**NEW YORK STATE THRUWAY AUTHORITY
DEPARTMENT OF ENGINEERING**

**ALBANY, NY
JANUARY 30, 2024**

**AMENDMENT NO. 2
TO**

**CONTRACT TAA 23-25B
D214941
THRUWAY BRIDGE REHABILITATION
OVER THE WALLKILL RIVER, MP 81.72
IN THE ALBANY DIVISION
OF THE NEW YORK STATE THRUWAY
IN ULSTER COUNTY**

TITLE OF PROJECT REHABILITATION OF I-87 BRIDGES OVER WALLKILL RIVER	CONTRACT NUMBER: TAA 23-25B
LOCATION OF PROJECT ALBANY DIVISION MP 81.72	DATE: 01/24/2024
TITLE OF DRAWING WORK ZONE TRAFFIC CONTROL TYPICAL SECTIONS - STAGE 2	DRAWING NUMBER: TC-2

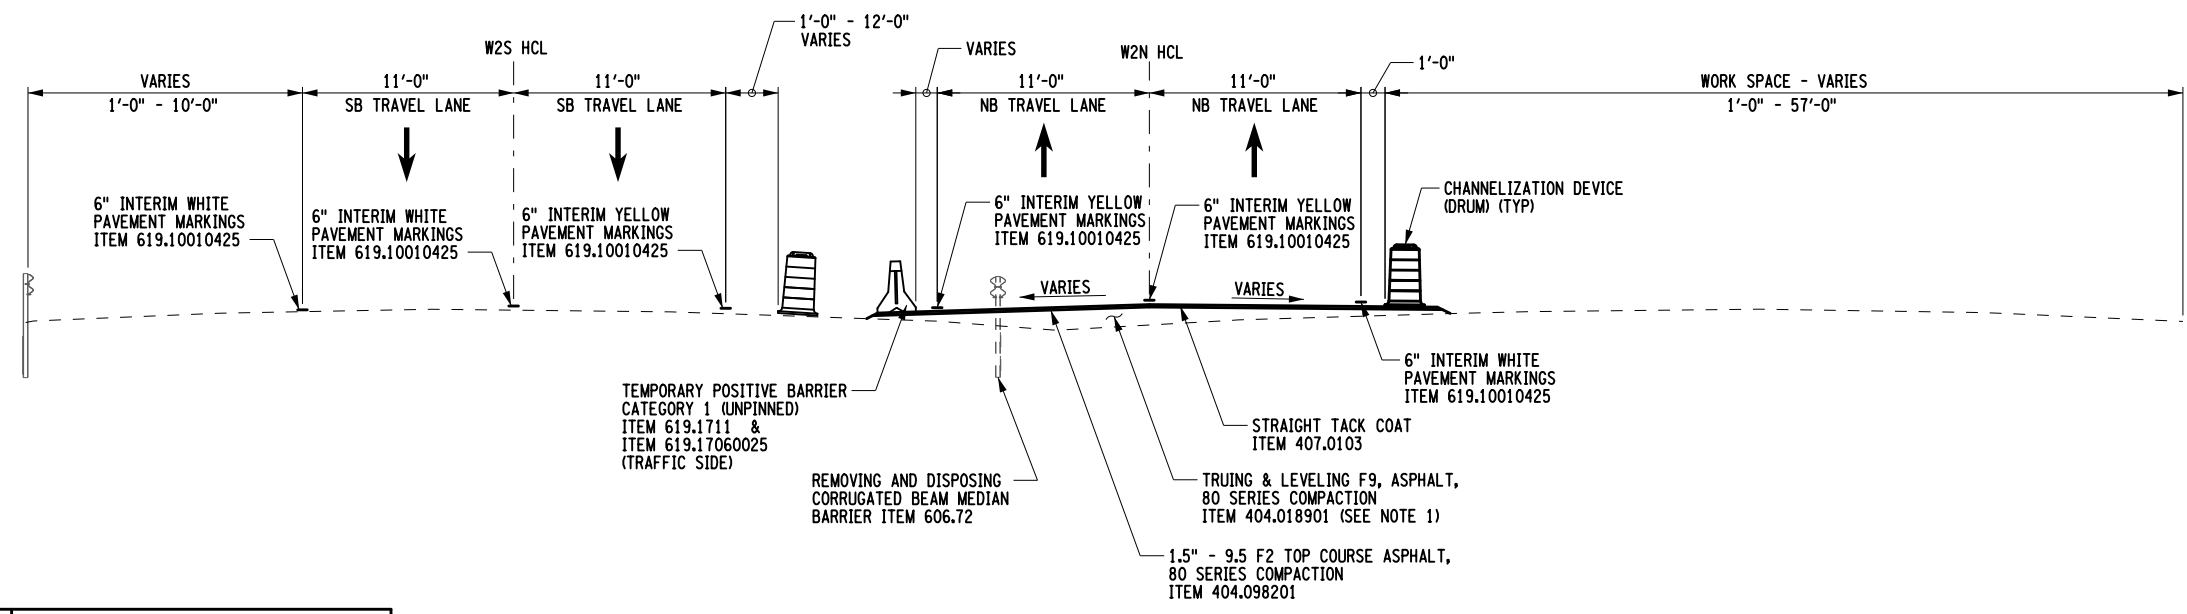
9. **DELETE** Drawing Number TC-2, Sheet 9 of 105 and **REPLACE** with the attached new Drawing Number TC-2-A2, Sheet 9-A2 of 105.
 - Change in Temporary Positive Barrier

TITLE OF PROJECT REHABILITATION OF I-87 BRIDGES OVER WALLKILL RIVER	CONTRACT NUMBER: TAA 23-25B
LOCATION OF PROJECT ALBANY DIVISION MP 81.72	DATE: 01/24/2024
TITLE OF DRAWING WORK ZONE TRAFFIC CONTROL PLANS - STAGE 2 WALLKILL BRIDGE (3 OF 8)	DRAWING NUMBER: TC-6

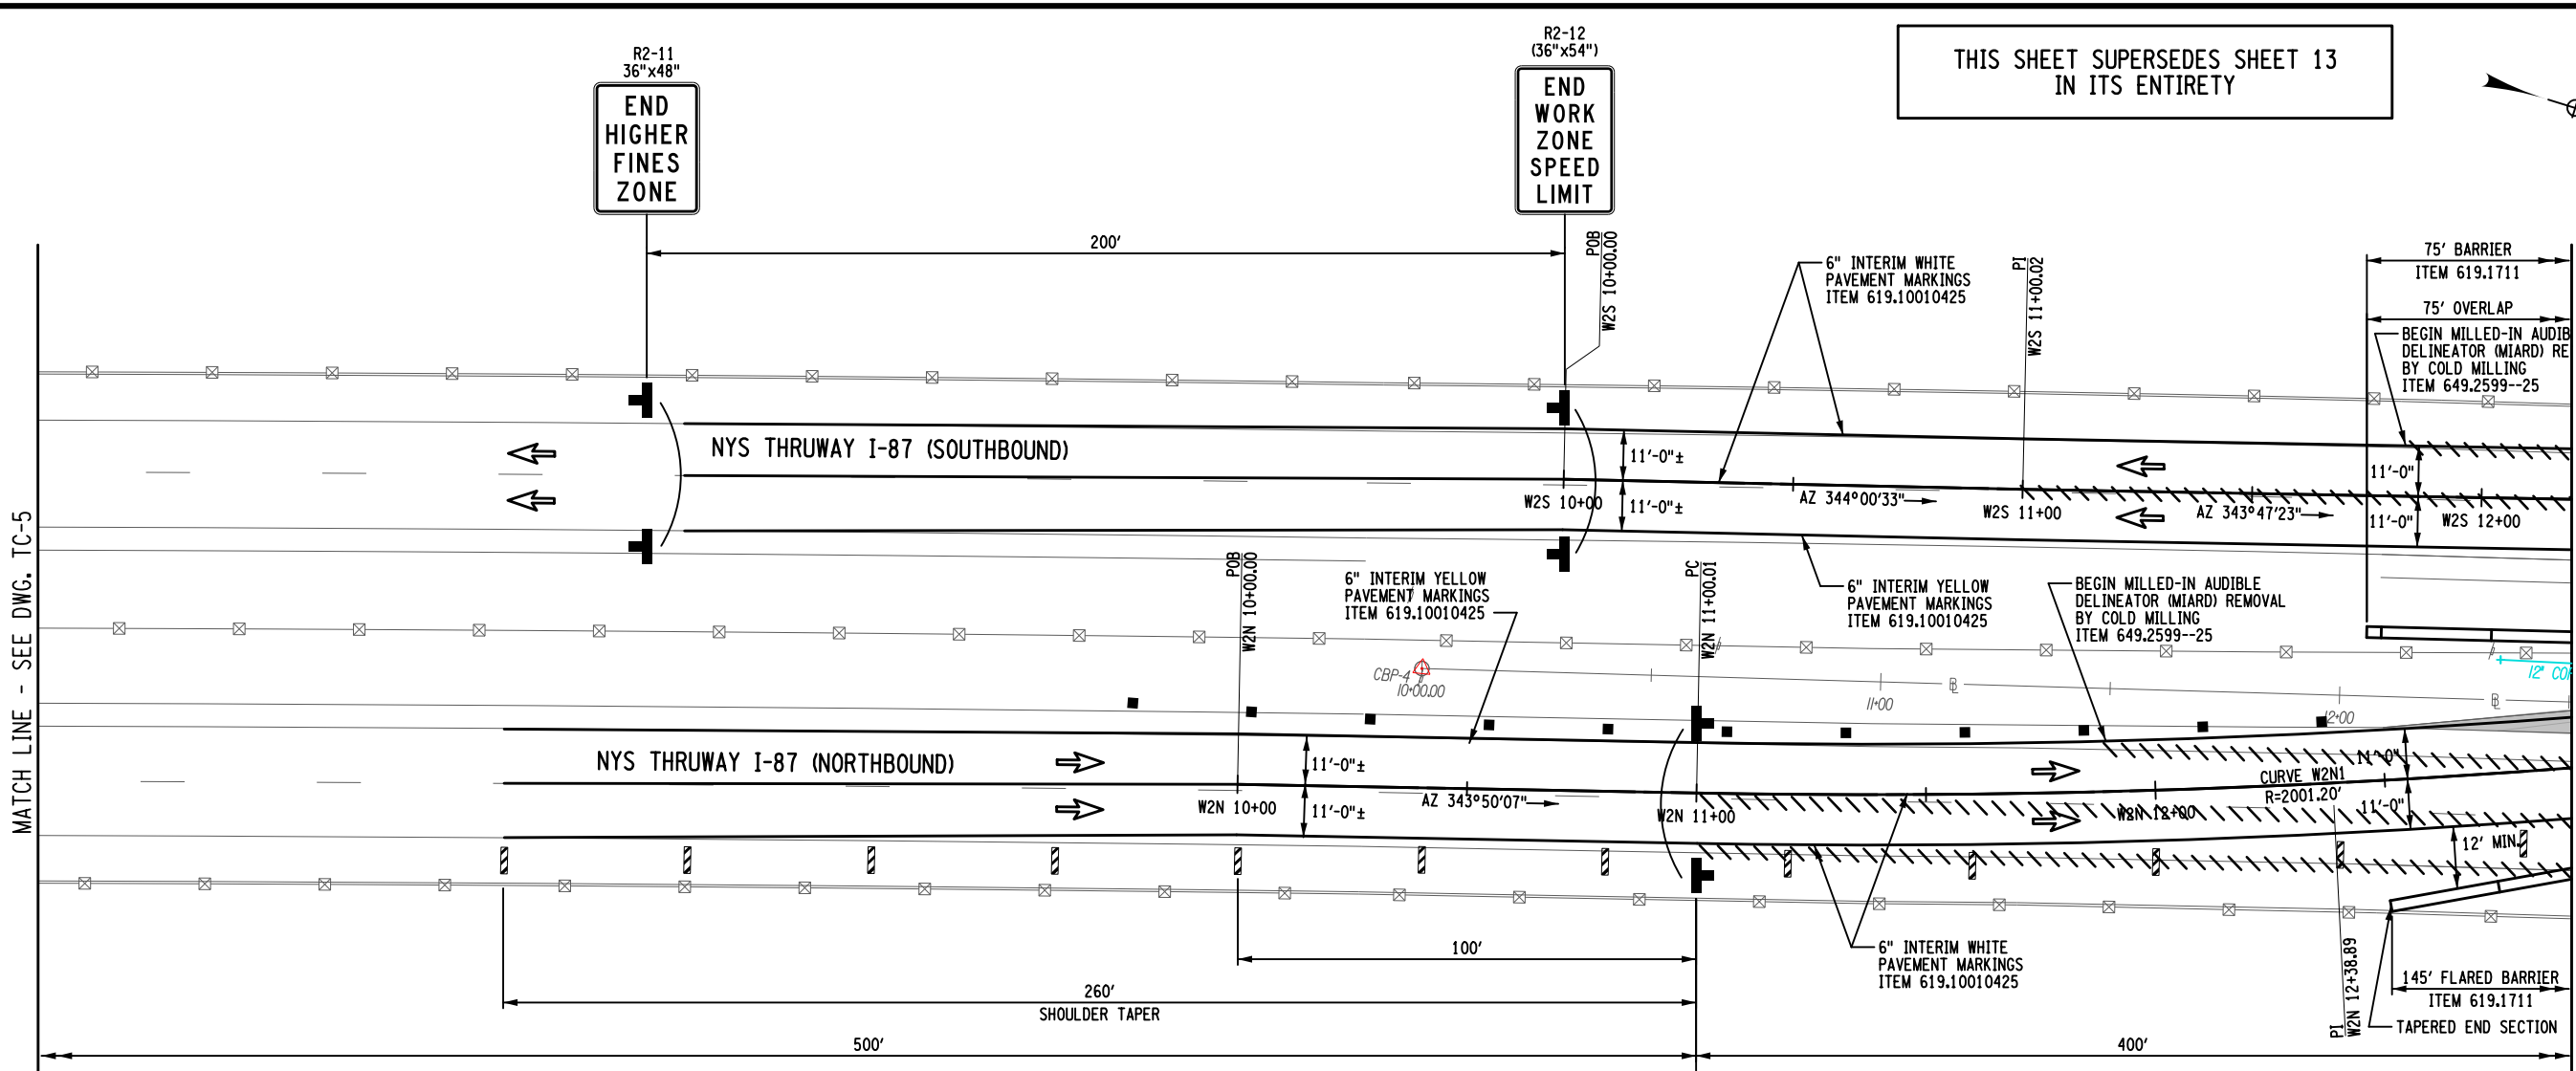
10. **DELETE** Drawing Number TC-6, Sheet 13 of 105 and **REPLACE** with the attached new Drawing Number TC-6-A2, Sheet 13-A2 of 105.
 - Change in Temporary Positive Barrier

TITLE OF PROJECT REHABILITATION OF I-87 BRIDGES OVER WALLKILL RIVER	CONTRACT NUMBER: TAA 23-25B
LOCATION OF PROJECT ALBANY DIVISION MP 81.72	DATE: 01/24/2024
TITLE OF DRAWING WORK ZONE TRAFFIC CONTROL PLANS - STAGE 2 WALLKILL BRIDGE (4 OF 8)	DRAWING NUMBER: TC-7

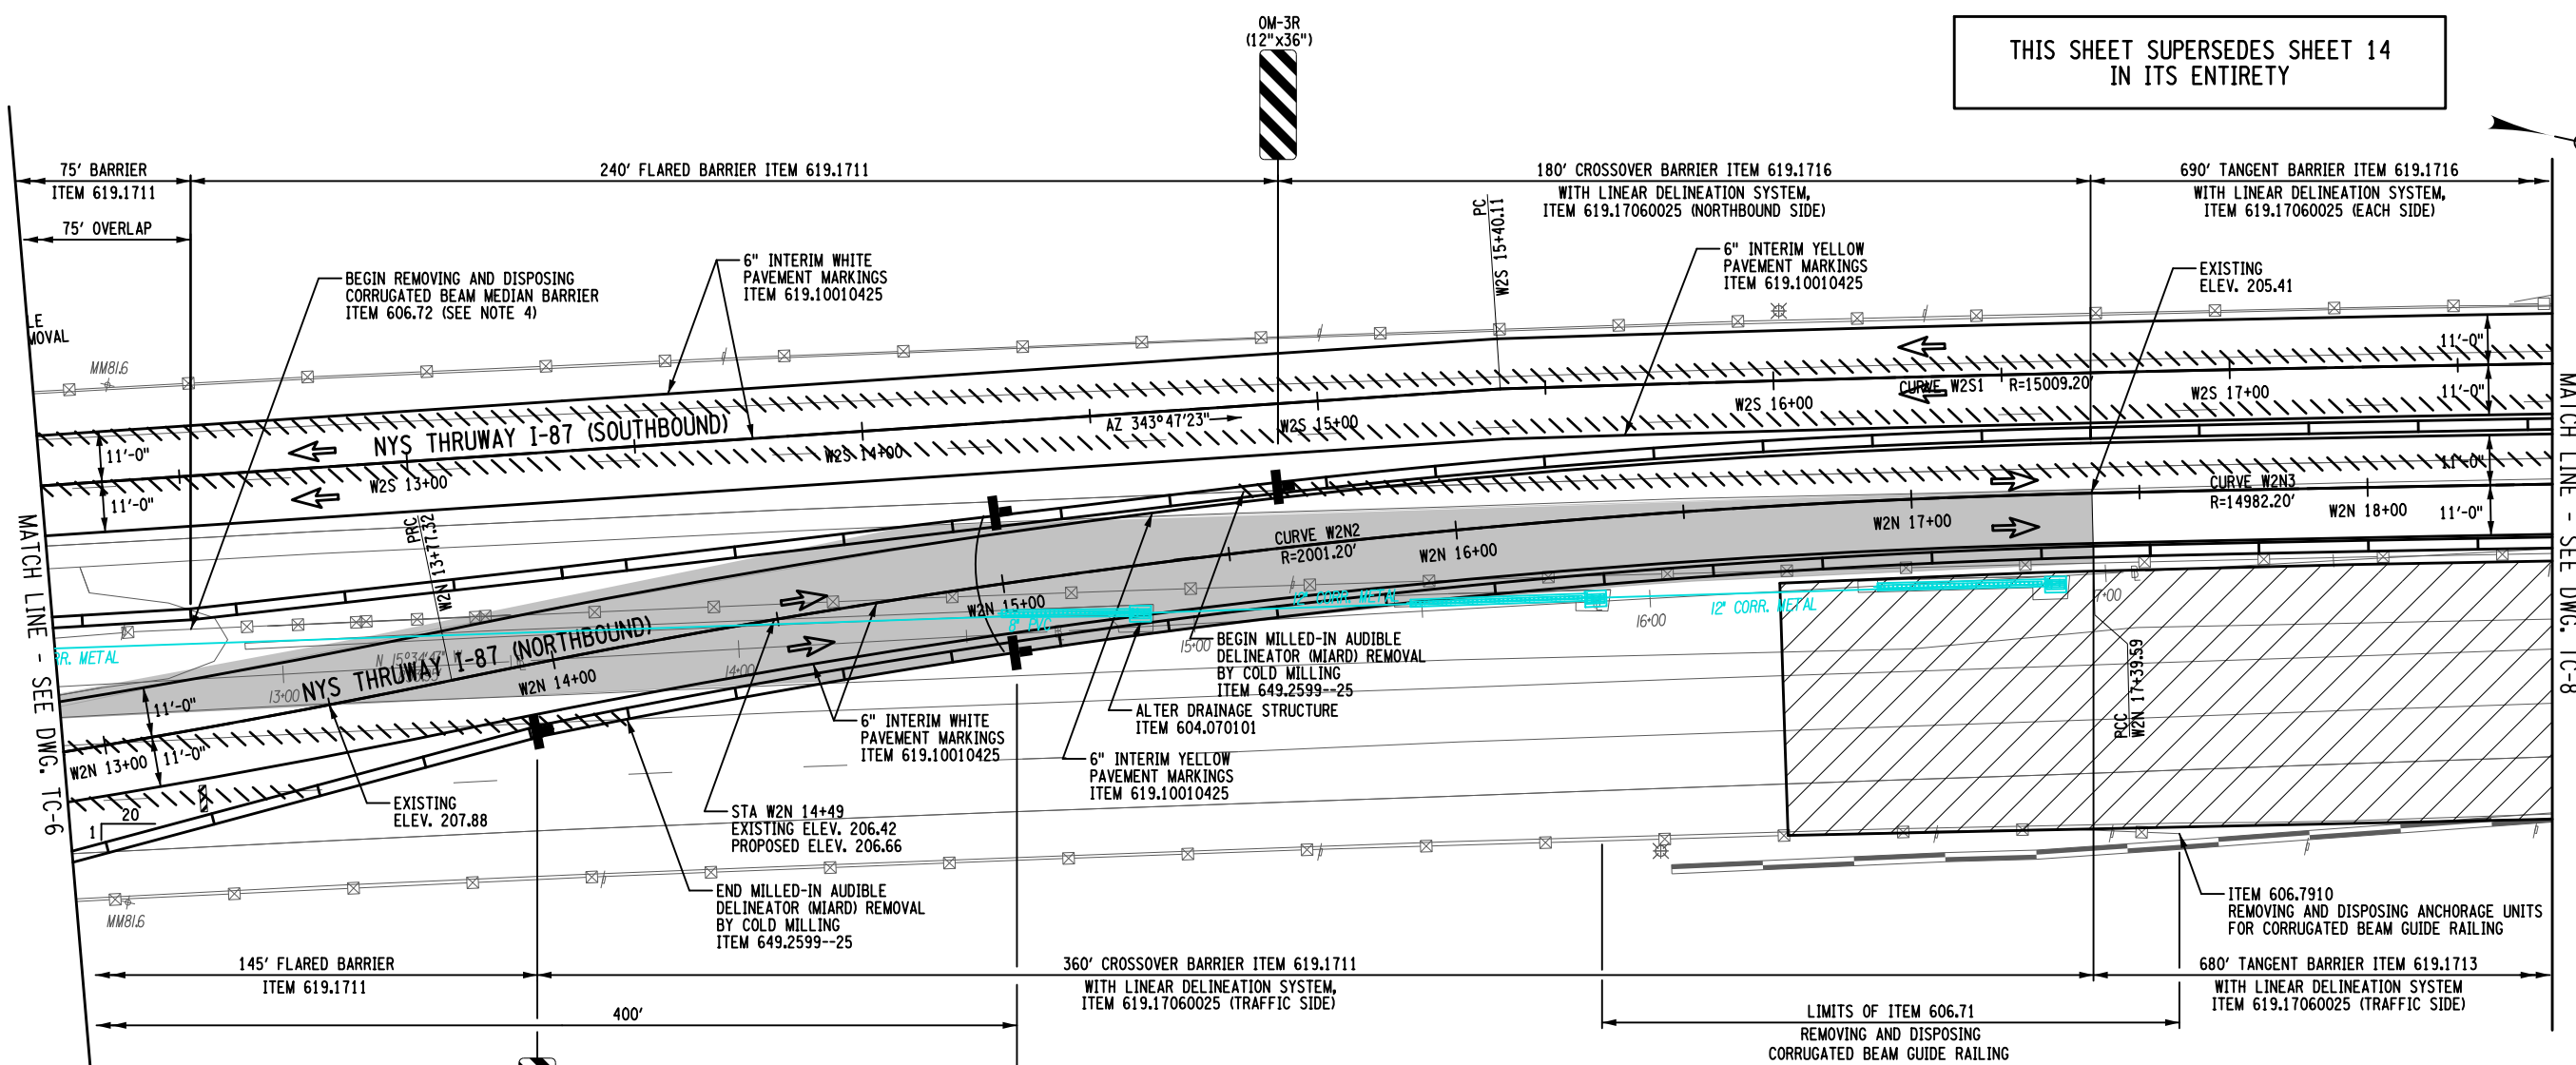
- Previous reference to (incorrect) Item 403.25990025 (STAR Removal) has been updated to Item number 649.2599--25
11. **DELETE** Drawing Number TC-7, Sheet 14 of 105 and **REPLACE** with the attached new Drawing Number TC-7-A2, Sheet 14-A2 of 105.

- Change in Temporary Positive Barrier
 - Previous reference to (incorrect) Item 403.25990025 (STAR Removal) has been updated to Item number 649.2599--25

TITLE OF PROJECT REHABILITATION OF I-87 BRIDGES OVER WALKKILL RIVER	CONTRACT NUMBER: TAA 23-25B
LOCATION OF PROJECT ALBANY DIVISION MP 81.72	DATE: 01/24/2024
TITLE OF DRAWING WORK ZONE TRAFFIC CONTROL PLANS - STAGE 2 WALKKILL BRIDGE (5 OF 8)	DRAWING NUMBER: TC-8

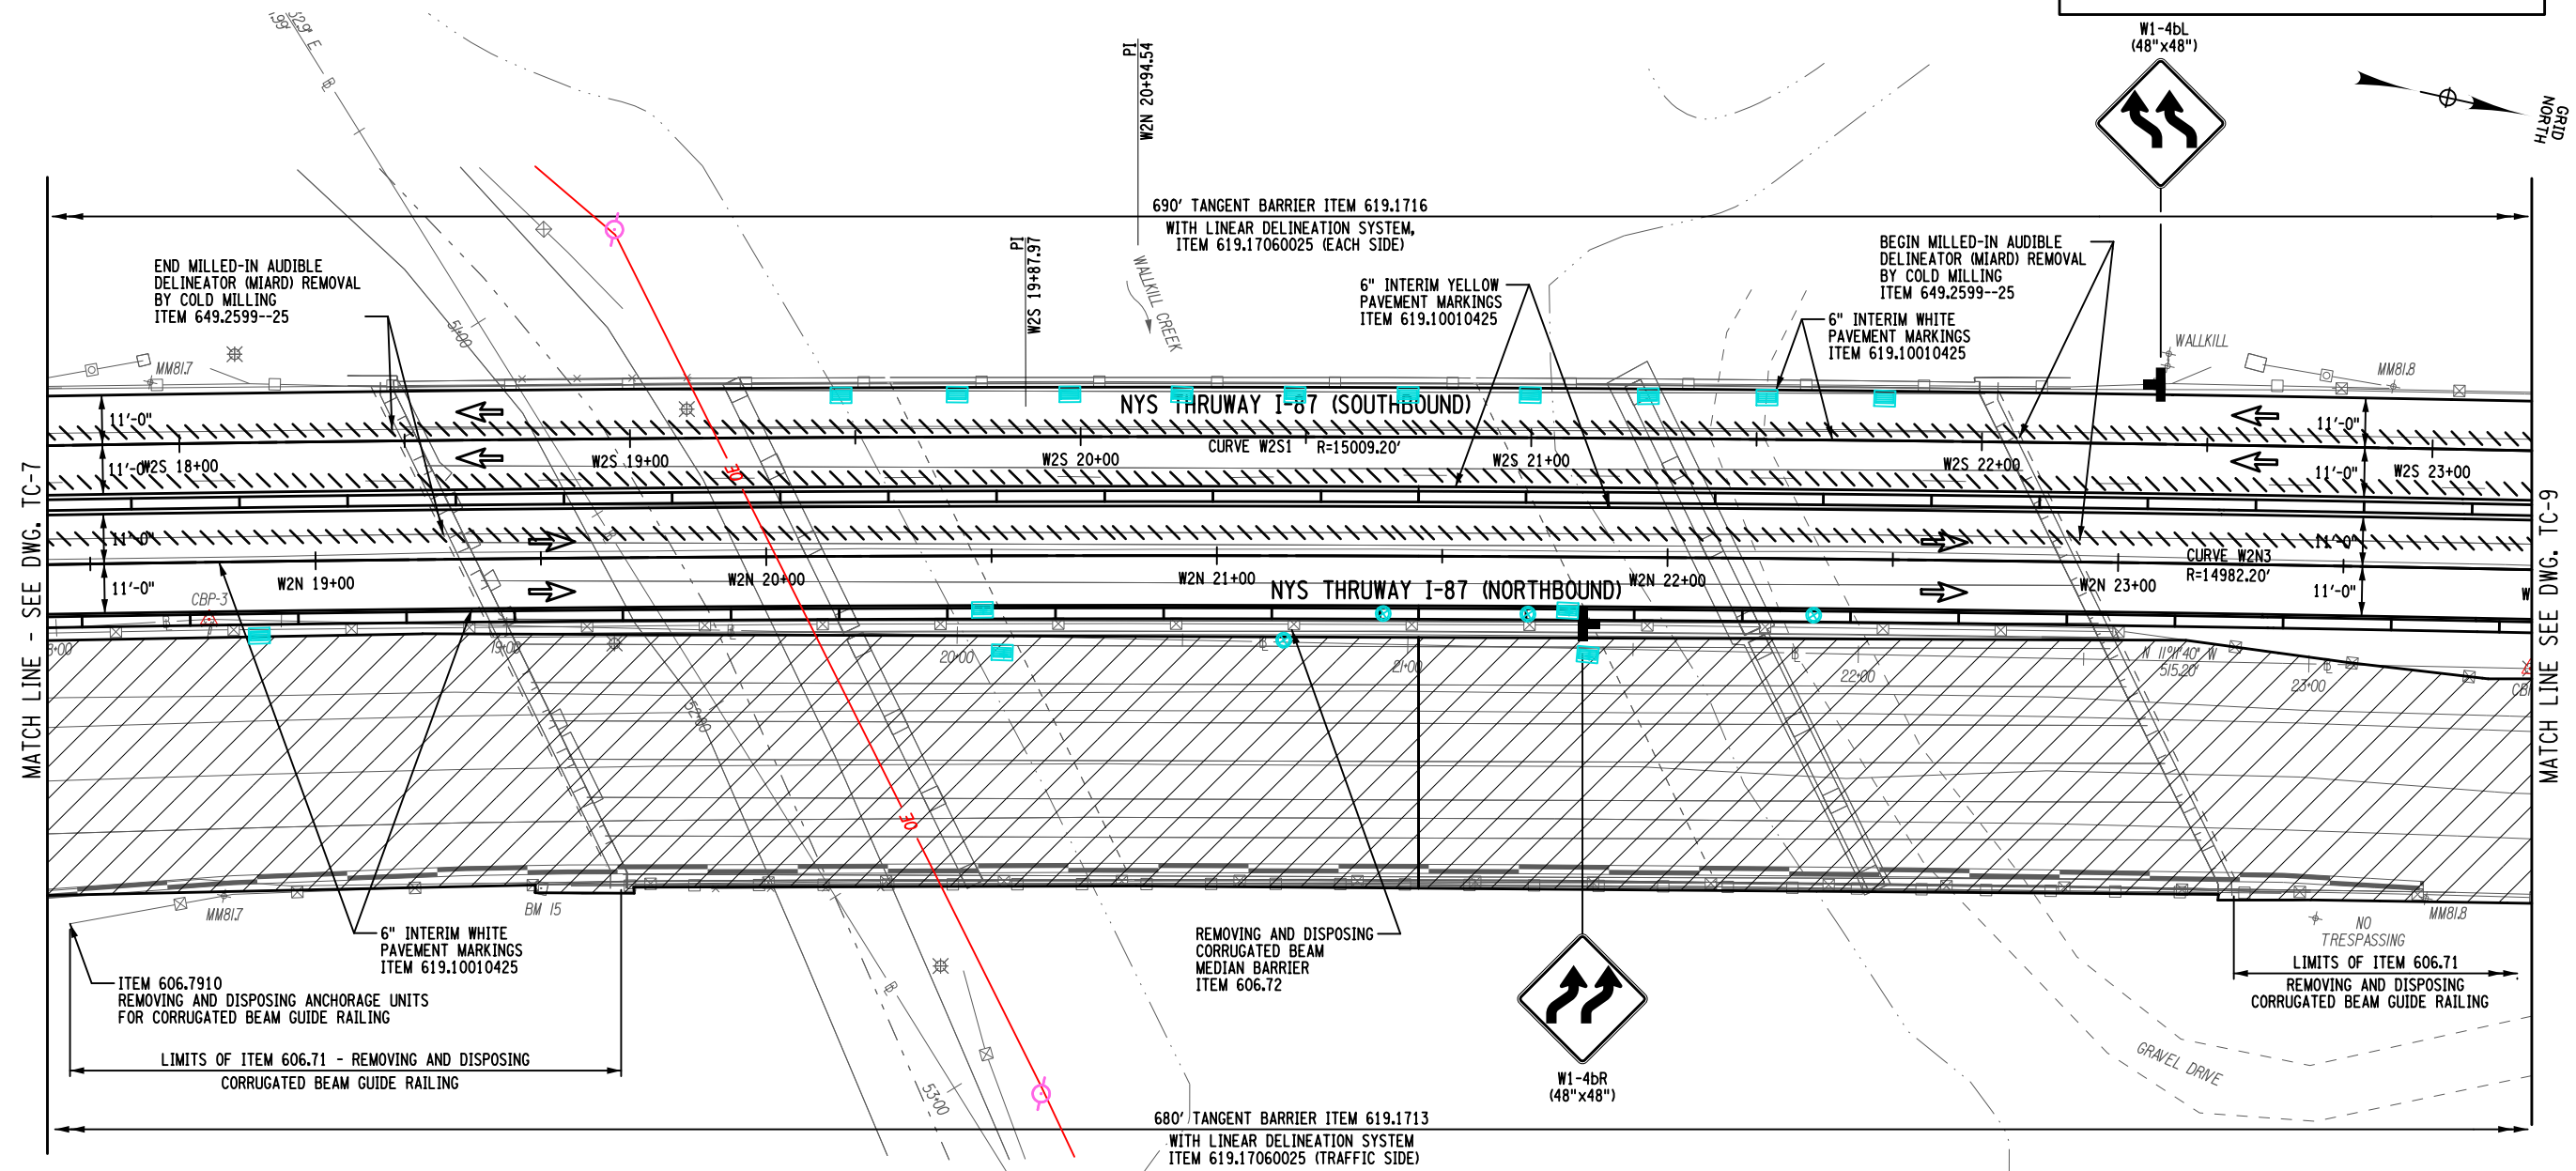
12. **DELETE** Drawing Number TC-8, Sheet 15 of 105 and **REPLACE** with the attached new Drawing Number TC-8-A2, Sheet 15-A2 of 105.
 - Change in Temporary Positive Barrier
